APPLICATION NO.	FILING DATE	FIRST NAMED INVENTOR	ATTORNEY DOCKET NO.	CONFIRMATION NO.
10/607,116	06/26/2003	Michael J. Berman	03-0538	3693
24319	7590	01/06/2005	EXAMINER	
LSI LOGIC CORPORATION 1621 BARBER LANE MS: D-106 MILPITAS, CA 95035			NGUYEN, GEORGE BINH MINH	
		ART UNIT		PAPER NUMBER
				3723
DATE MAILED: 01/06/2005

Office Action Summary	Application No.	Applicant(s)
	10/607,116	BERMAN, MICHAEL
	Examiner	Art Unit
	George Nguyen	3723

DETAILED ACTION

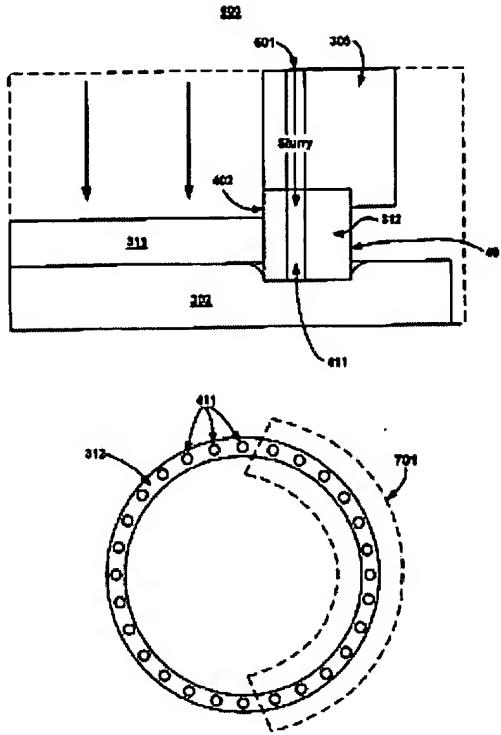
1. Claims 1-4 and 6-7 are rejected under 35 U.S.C. 103(a) as being unpatentable over Drill'6,347,979 in view of Tanaka'5,902,173.

With reference to Figure 6B, col. 7, lines 47-56, Drill discloses the claimed invention except for the at least one channel in communication with the plurality of outlets 411.

With reference now to FIG. 6A and FIG. 6B, FIG. 6A shows a side cut away view of wafer 311 and dispensing ring 312, as wafer 311 and dispensing ring 312 are positioned on top of pad 302. FIG. 6A also shows an area 600, which is shown in greater detail in FIG. 6B. As depicted in FIG. 6B, area 600 shows wafer 311 receiving a downward directed force from the carrier (not shown). Wafer 311 is confined in place on pad 302 by inner radius surface 402. Dispensing ring 312 receives a downward force from arm 306 and is pressed into the resilient surface of pad 302.

In the present embodiment, arm 306 includes a plurality of slurry passages (e.g., passage 601) which align with each of the slurry dispense holes 411. CMP machine 300 pumps slurry through the slurry passages 601, through the slurry dispense holes 411, onto pad 302, and into contact with wafer 311.

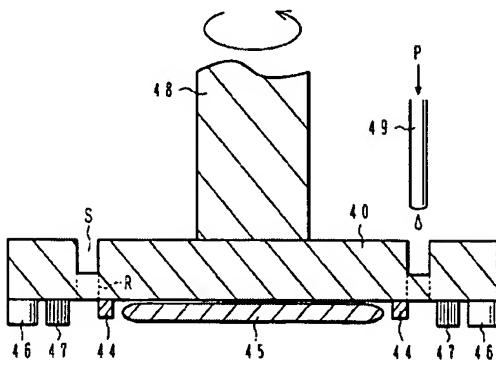
With reference to Figure 22, col. 7, lines 43-59, Tanaka teaches that it is known to have utilized at least one channel S in communication with a number of holes R so that polishing agent P can be supplied therefore from a dispensing nozzle 49 to the wafer 45 via the groove S and holes R. The advantage is to provide a uniform slurry supply to the holes.

The feature of the tool/wafer holder 40 shown in FIG. 23 is that a tool holder unit 40b with a lapping tool 46 is rotated independently from a wafer holder unit 40a with a brush 47. Specifically, the lapping tool 46 is adhered to the bottom of the tool holder unit 40b which is mounted covering the wafer holder 40b, whereas the brush 47 is adhered to the bottom of the wafer holder unit 40a. The tool holder unit 40b is rotated by a rotary shaft 48b disposed coaxially with, and outside of, a rotary shaft 48a for rotating the wafer holder unit 40a. A groove Sa is formed in the tool holder unit 40b, and a groove S corresponding in position to the groove Sa is formed in the wafer holder unit 40a. A number of holes R are formed in the groove S, opening to the bottom surface of the wafer holding tool 40a. Polishing agent P can be supplied therefore from a dispensing nozzle 49 to the wafer 45 via the grooves Sa and S and holes R.

Thus, it would have been obvious to one having ordinary skill in the art at the time the invention was made to have modified the wear ring 312 Drill with one common inlet S as taught by Tanaka in order to provide a uniform slurry supply to the holes.
